SERVICE BULLETIN

Classification: HA22-003	Reference: NTB22-023	Date: March 22, 2022
-----------------------------	-------------------------	-------------------------

BLOWER MOTOR MAKES CLICKING NOISE DUE TO SNOW INTRUSION

APPLIED VEHICLES: 2021 Rogue (T33)

Figure 1

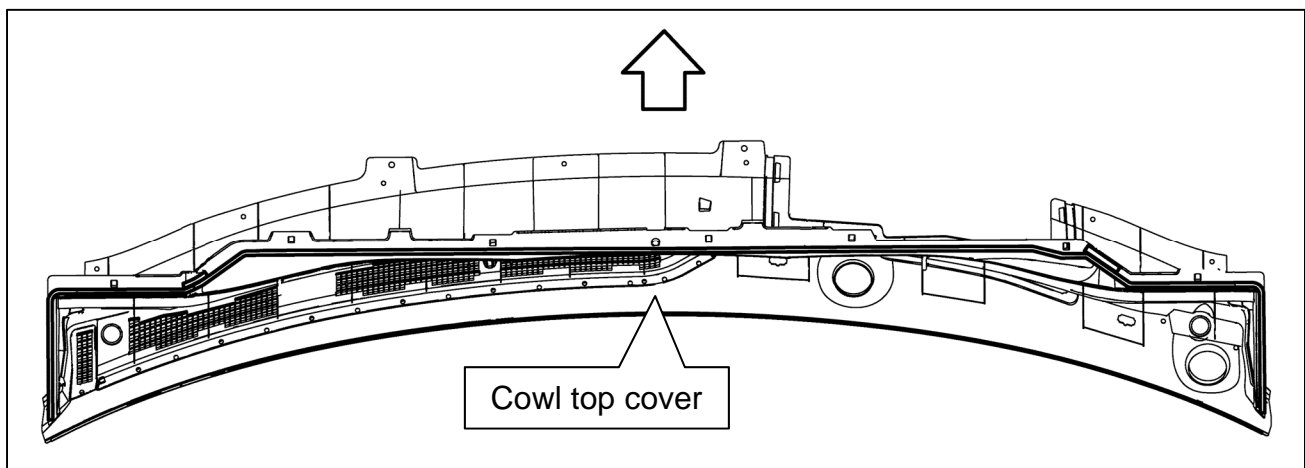
Replace the cowl top cover with one from the **PARTS INFORMATION**.
